# GOLDEN GATEWAY PROPOSALS

#### ARCHITECTURAL ADVISORY PANEL . EVALUATION REPORT

PREPARED BY MARIO J. CIAMPI, FAIA, CHAIRMAN

### WELTON BECKET & ASSOCIATES LAWRENCE LACKEY

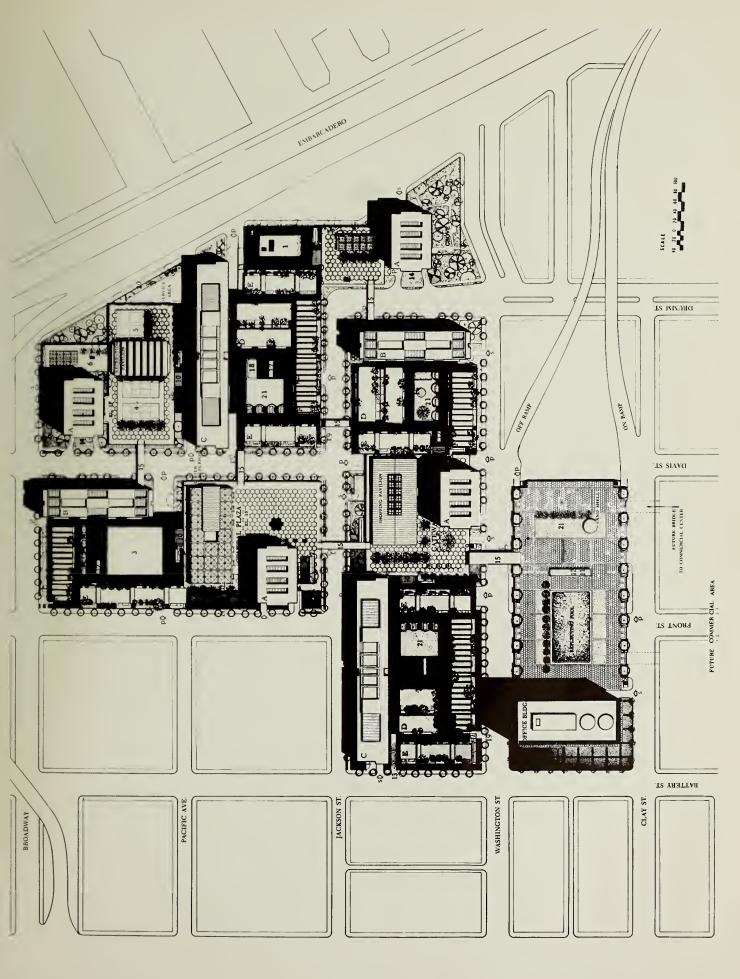
The authors of this project have made a serious effort to provide a total environment for its occupants. The physical, cultural and spiritual aspects of life, as well as the relationship of the occupants to the general surrounding environment, have been given serious attention. The automobile has been kept in its proper place and the pedestrian circulations have been elevated to form a complete separation between the two functions.

The general plan relates well with the city grid pattern. It does not, however, relate well with the existing Customs House. Furthermore, certain buildings have been placed too close to the elevated freeway, which would result in an obnoxious conflict between heavy traffic and domestic life.

The general apartment area seems to have been worked out block by block with emphasis on charm and detail rather than as a unified whole, and there is a resulting lack of restfulness and serenity.

The interrelationship between high and low rise buildings is crowded and confused. The high rise apartment buildings appear more like office buildings than elements for living, and the unprotected balconies do not appear useful. While the concept of bridges between the various blocks is excellent, they should be more pronounced and stronger as architectural statements.

The office building has been very well studied in its relationship to the mall and public garage. There is some question, however, that it may be too high and out of scale with the surrounding financial district.

It is generally concluded that this scheme lacks a sufficiently strong philosophy or concept to provide order, clarity and a distinguished architectural and environmental statement.

#### JAN LUBICZ-NYCZ & ASSOCIATES

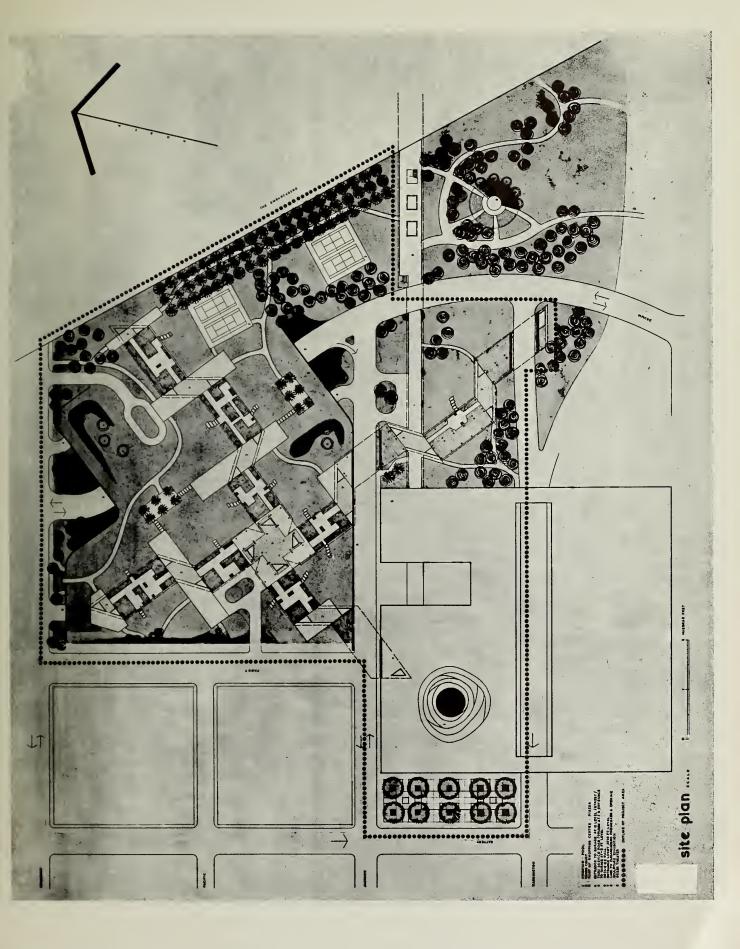
The basic concept of this proposal is remarkably bold, dynamic and brilliantly provocative. A wonderfully large space in the downtown area is created and an excellent relationship with Portsmouth Square, Ferry Park, the public garage and Customs House is achieved. Located in a handsome park setting, the apartment structure is a strong sculptural statement endeavoring to capture the Telegraph Hill spirit of living environment. In concept, this structure may be said to be beyond the conventional wisdom of architecture today and would undoubtedly be a major influence on future architectural design.

The scheme, however, is decidedly preliminary in nature, with numerous inherent problems unexplored. A very serious question is raised as to the ability of achieving in final execution an excellence comparable to the original principles. And assuredly, this outspoken structure would demand excellence in all detail.

Vehicular traffic is successfully separated from the pedestrian, and the apartments are generally very well removed from the freeway. The unit apartment plans are excellent and enjoy a privacy, a delight in the surrounding park, and magnificent views of the city and bay. The site planning of all secondary elements, however, is quite weak.

The central apartment structure should lend itself to construction at reasonable cost and to apartment units of reasonable basic rentals. Vertical circulations for the 33 stories would, however, be extremely wasteful.

Despite the highly commendable freshness of this proposal, the design expression is a very personal one, largely lacking in the restraint of civic and social direction. This alone is cause for considerable concern. Moreover, there is a disturbing restlessness to the commanding structure which, together with its overwhelming scale, seems at odds with basic needs of a living environment. This great scale, furthermore, seems particularly inappropriate to the scale of the city.

ANGUS McSWEENEY DONALD BEACH KIRBY LOUBET & GLYNN

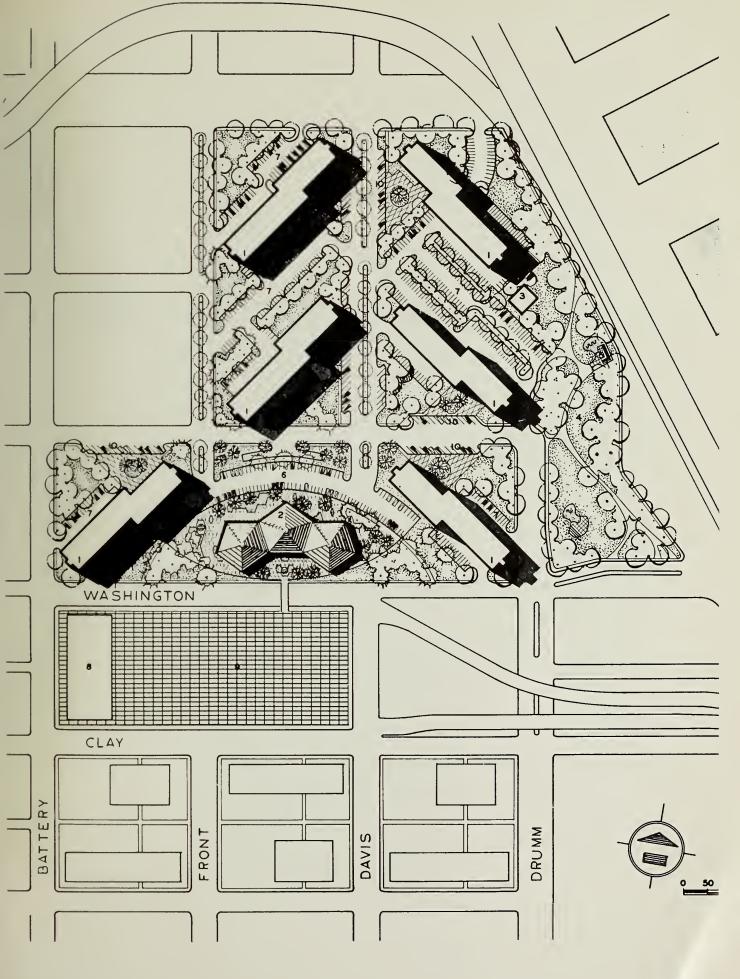
The scheme appears to be motivated by economic factors with an absolute minimum regard for visual and environmental aspects. It is evident that the intent is to reproduce the same plan six times in order to standardize construction and reduce fees. Despite this, the proposed rent schedules indicate the apartments will be very expensive. A greater variety of apartment types would also be desirable.

The chevron plan creates a disturbing conflict with the normal grid pattern of the surrounding city. The relationship of the apartment area to the freeway ramps, public garage and proposed office building is very poorly considered. No logical design connection with these elements exists. The proposed axis has reason neither for beginning nor end. No attempt has been made to separate the pedestrian from the automobile and, in fact, saturation of the site by automobiles is invited. The choice of partial basement garage parking and extensive surface parking is, at best, a very indecisive solution to the problem.

The slab structures, with a relatively high density, allow a great deal of open space, yet these spaces are in no real way utilized as a joyful environment for people.

This is a static and oppressive scheme, completely at variance with the most significant considerations for the beginning of redevelopment in this area of the city. The proposal is very similar in character to public housing projects constructed in many parts of the country, and fails completely to provide an appropriate environment of charm and delight for our citizens.

ANSHEN & ALLEN

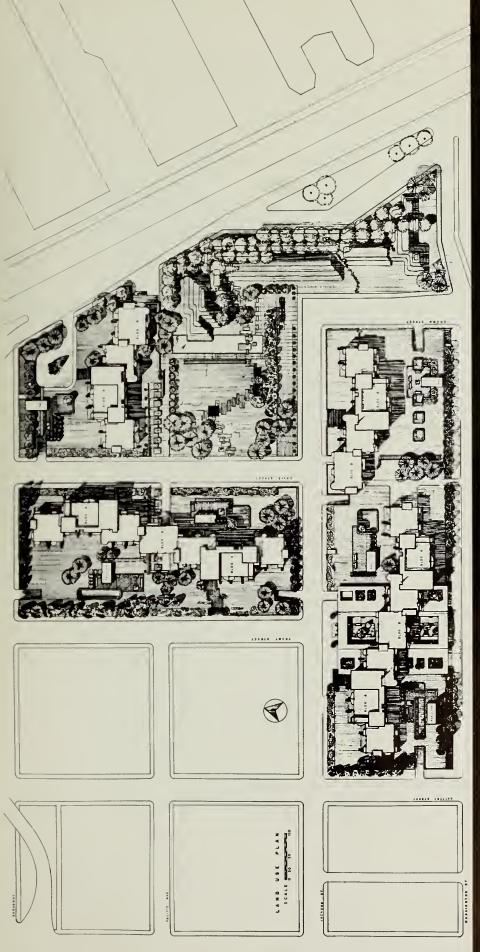
Basic to this proposal is the effort to recreate the characteristic informality of the city's residential skyline. In this direction, the attempt at variegation and fragmentation of the building façades is refreshing as an idea but not successfully executed. The façades seem artificial in their endeavor to imitate a pattern which appears accidentally in the cityscape, and the repeating of this accident throughout the project contradicts its freshness. Furthermore, the buildings are actually corridor-type slab structures masquerading as separate towers. The vertical stripes, emphasized by color, create a very nervous and restless character which, when repeated in such large areas, becomes monotonous. The absence of sufficient variation between masses and voids presents a rather formidable aspect.

A very serious effort has been made to conceal the elevated freeway by the construction of an earth berm which could be handsomely landscaped, and a central recreation area has been provided to give an openness to the center of the site. The casual treatment of the open spaces, almost like a private yard extended, seems, however, badly out of scale. There is no interconnection of the buildings with these spaces and no unity of the whole composition toward a single enjoyment of an open space. Little relation is made with the adjoining office building and public garage area and no suggestion is given of extension into, or integration with, adjacent areas of the city.

The separation of vehicular traffic and pedestrian traffic is not well worked out. Placing the garages in the basements and keeping the principal pedestrian circulation at street level creates hazardous and undesirable conflicts between the families who would occupy the area and the heavy downtown traffic. These garages are further considered to be needlessly expensive.

The shopping center seems poorly placed under one of the towers. It is not centrally located nor properly expressed as a shopping center with its glamour, gaiety and special character. Furthermore, it would be in conflict with the apartments overhead and create problems within the tower structures.

At first impression, this proposal appears quite interesting and its central concept quite promising. Upon closer scrutiny, however, it fails that promise. A clear distinction exists between representing or recreating the character of a city and capturing the essence or spirit of that character. This proposal does not give assurance that it has made that distinction.

### DANIEL, MANN, JOHNSON & MENDENHALL CORLETT & SPACKMAN

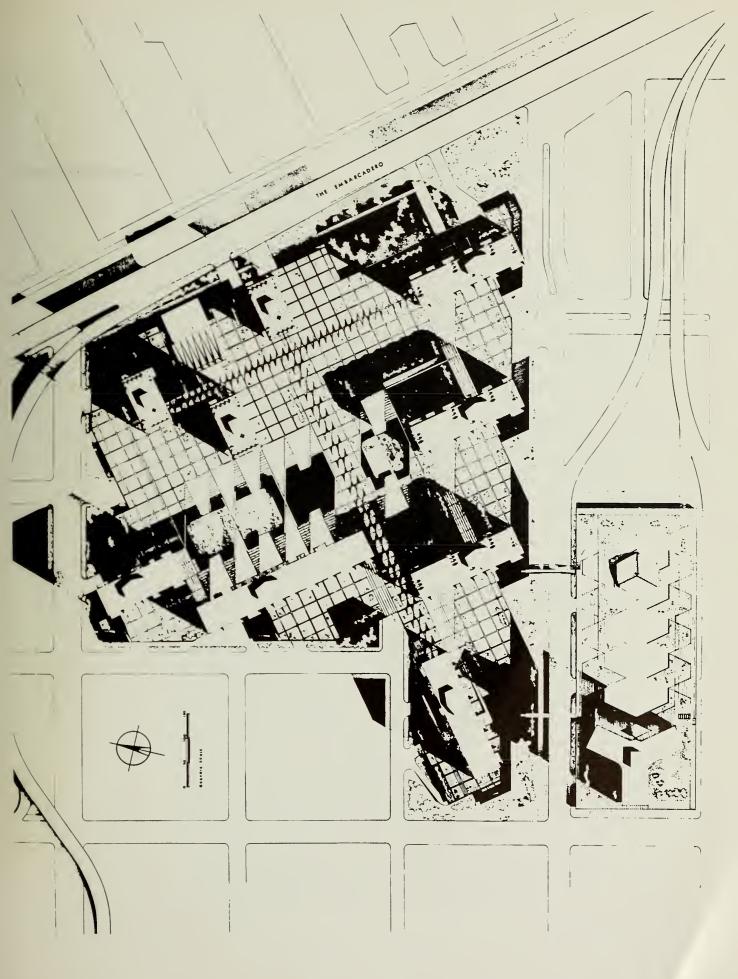
Basic to the site planning of this proposal is the decision to ignore the city proper and relate the entire project to the freeway and harbor. This results in a very unhappy conflict with the surrounding grid pattern and a marked isolation of the project.

The pedestrian plateau is an imaginative idea with certain virtues. Three distinct levels of circulation connecting with the street pattern are created, and separation of vehicular traffic and the pedestrian is achieved. This concept could possibly be carried out in the development of surrounding areas as urban change and growth continue. The pedestrian plateau suggests, however, a bleak and barren expanse for a living environment, and provision of appropriate landscaping would present formidable considerations of structure and cost.

The shopping center is well placed and such amenities as recreation facilities have merit. However, the apartment buildings are located too closely to the elevated freeway and would be exposed to undesirable noise, night lights and confusing motion.

The high-rise apartment building for elderly citizens is most unanimously and emphatically rejected. This is particularly undesirable sociologically and psychologically.

The main structures, through their placement, size and consistency of height, somehow succeed in occupying even more space visually than physically. It would be difficult to see into or out of the canyons which are created. This prospect is made even more frightening by the absolute pervasiveness of ostentatious surfaces and bizarre forms. Projecting balconies are very exposed and would not be practical in this city.

Rather than gaining from, or lending to, the spirit of the city, this scheme loudly projects itself in sharp conflict with that spirit.

JOHN CARL WARNECKE & ASSOCIATES
GARDNER DAILEY & ASSOCIATES
VICTOR GRUEN & ASSOCIATES

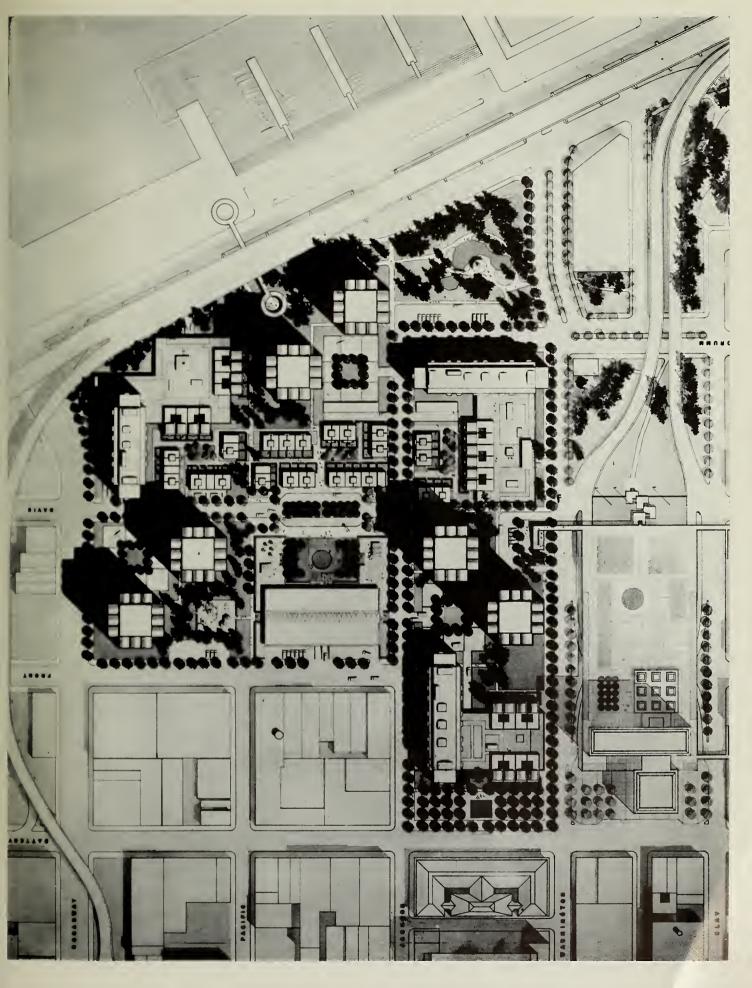
There is unanimous admiration of this proposal. It is a sensitive and distinguished solution to a very difficult problem. The carefully studied plan integrates well with the city grid pattern. A variety, elegance and charm, so vital to city living, is apparent. This variety, however, is not without its conflicts.

The high rise apartment towers are exceptionally handsome and graceful. The slab apartment structures, by comparison, however, are of rather uninteresting design. They might well be improved with a more chateau-like character. If these apartments were planned to include low rental units, as opposed to the luxury rentals of the towers, occupancy would be brought into range of a greater number of people. The project would thereby become more marketable. Despite their beauty, some concern was voiced that the apartment towers might be more appropriate with greater variety of design.

The town houses give rise to particular concern. They complicate the project and appear too expensive to justify. The area claimed by these houses could be utilized to better advantage as open space for the several thousand occupants of the project.

Relationship with the Customs House and future harbor development is good. Landscaping and separation of the site into small manageable land areas appears successful.

Inadequate consideration has been given the presence of the elevated freeway. The project too closely approaches this highly undesirable element, whereas the provision of at least a greenbelt buffer would have alleviated this problem.

Considerable concern was manifest over the street pattern within the project. Positive separation of the pedestrian and vehicular traffic has not been provided, and this is especially hazardous for families occupying the area. The garages, however, are well placed. The central plaza, with the shopping center, is particularly well conceived.

SITE PLAN

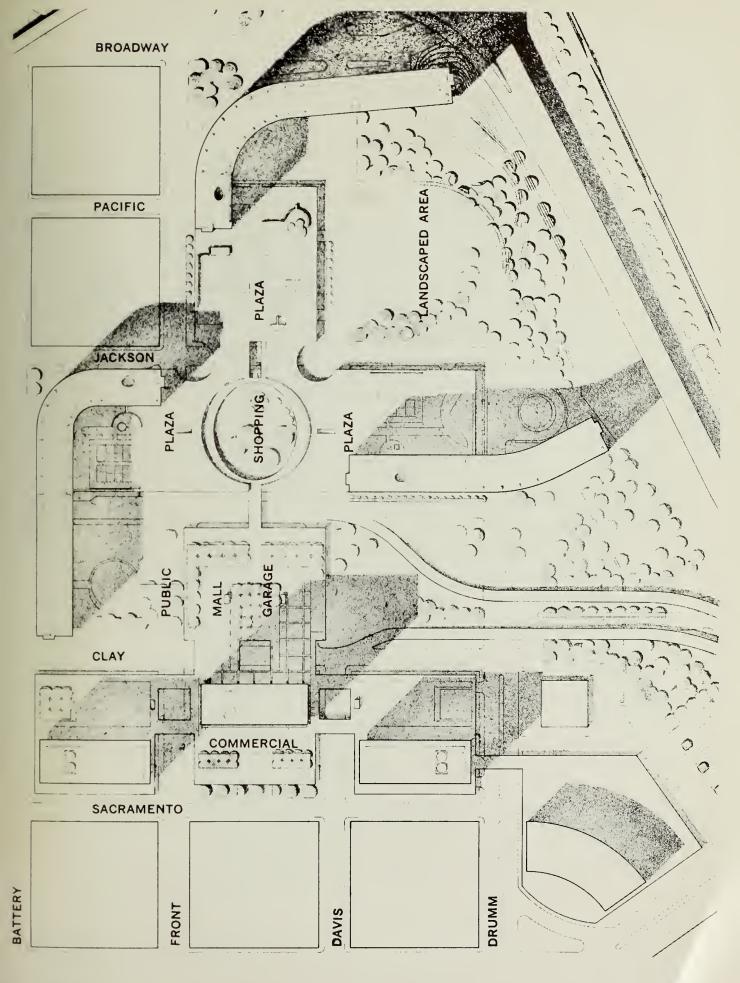
This is an eloquent and impressive proposal, boldly conceived and beautifully presented. It is an extremely monumental concept and if executed would be an architectural statement of grandeur unique in our country. There is exceptional virtue in its spaciousness, and in the creation of its great park. A civic development of this magnitude, immediately adjacent to a congested financial district could, in many respects, be a great asset to any city.

This very magnificence in a residential environment, however, presents grave considerations. The very size of the three apartment structures is awesome and out of scale with the surrounding city. There is a giantism and somewhat inhuman character prevalent. While admiring the stature of the buildings, one seriously questions the reaction to living in them.

The formidable aspect of the great walls presented might somewhat be relieved by more penetration, or opening up, of the structures. The curved form of these structures seems poorly considered.

The central plaza housing the garages, with the shopping center sculpturally expressed in the form of a circular sunken garden, is particularly handsome, and very well related to the apartment building. The scale of the unsightly elevated freeway has been very well recognized, and the buildings are well composed with this existing element. Eliminating the very strong symmetrical approach from the freeway ramps to the public garage is especially noteworthy.

The pedestrian has been very well isolated from automotive traffic. This concept as presented might very well be continued in surrounding areas in the city's future growth.

The project is well related to the Ferry Park and to harbor development, but completely destroys all view of the bay from the opposite side of the city. The proposed office building is excellently located and is a real contribution to the project.

While the great open spaces here are especially appealing, it is greatly feared the autocratic nature of this scheme would mar the finer scale and sensitive setting that make this city unique.

## PERINI-SAN FRANCISCO ASSOCIATES WURSTER, BERNARDI & EMMONS

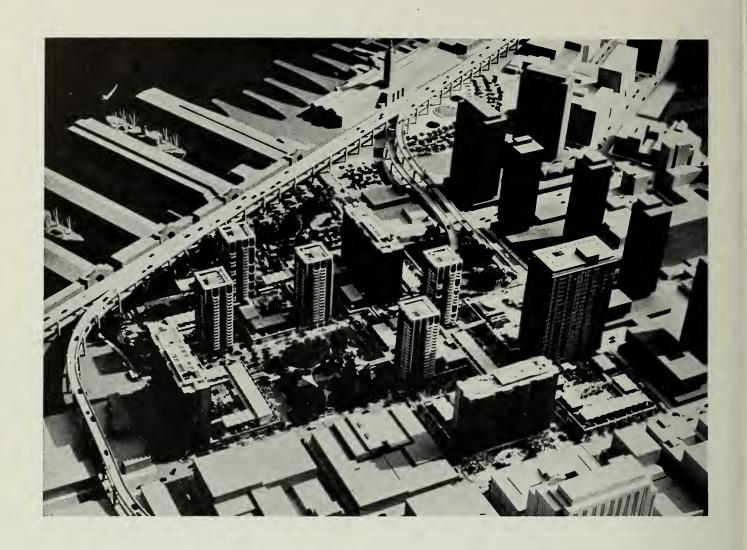
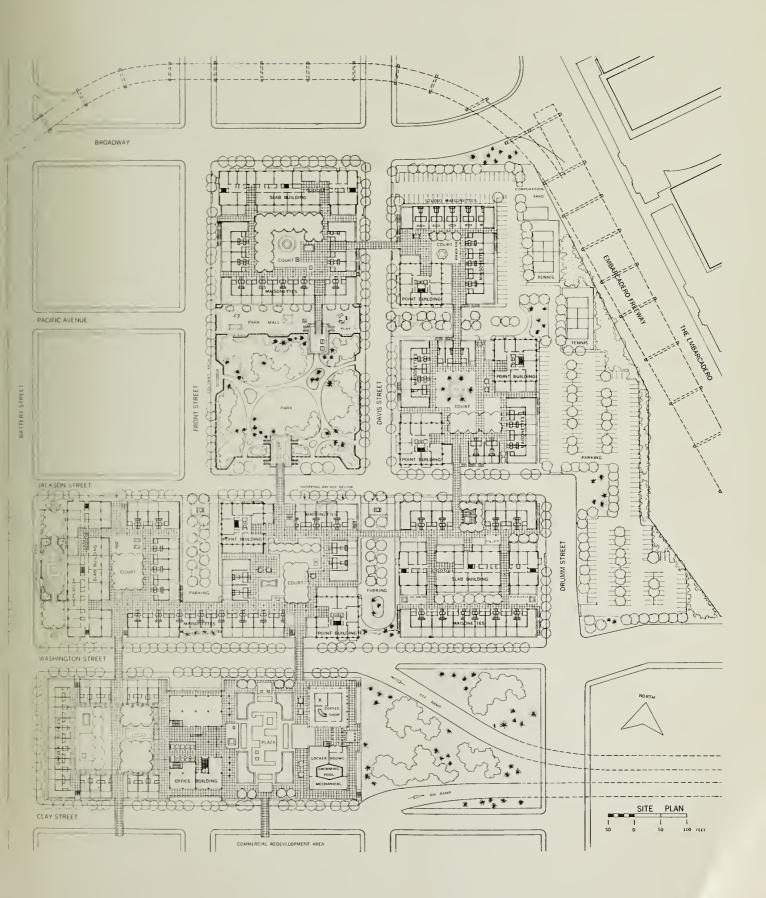
Agreement is unanimous that this proposal is exceptionally successful. The plan is remarkably sensitive with an intimate, yet urban, character. The basic concept of combining high rise and low rise structures is convincingly presented. This proposal further succeeds in establishing a prototype solution for high density residential development of gridiron blocks, within the context of the city's general pattern. This has special significance for future growth.

Elevating the pedestrian onto plazas which form the roofs of the garages, and which are connected together with bridges over the streets, is excellently conceived. This complete separation of people and vehicular traffic is fundamental to the life of the area. While achieving this separation, the automobile has not simply been buried, but has been granted its claim to streets of valuable access.

The scale of the buildings is good. The tower and slab apartment buildings, and the office building, are well composed with the nearby Financial District and Customs House. Buildings have been effectively moved back from the elevated freeway. This general separation from the inherent acoustical problems, glare, and motion of the freeway could have been further enhanced if the large surface parking lot were developed as a greenbelt or park. The handsome central park, with its focal position and ease of access by bridges, is excellent. The maisonettes are considered well related to the towers except that they are too numerous and perhaps should appear more anonymous. They also appear quite expensive.

The tower apartments and slab structures are not considered very well studied individually. Their color is rather garish and the balconies impractical. This is also true of the proposed office building. However, there is convincing reason to believe this would be resolved by further study. The suggestion has been made that other talented architects could well be employed to give these buildings more individual character and elegance of their own.

This proposal has generated great enthusiasm. The competence evidenced by its authors gives assurance of their ability to carry through to actual completion the eloquent concept they have presented. The pattern of relationships between buildings would be a fine extension of the city; and the warmth, intimate character and variety of form and space promise a delightful human environment.
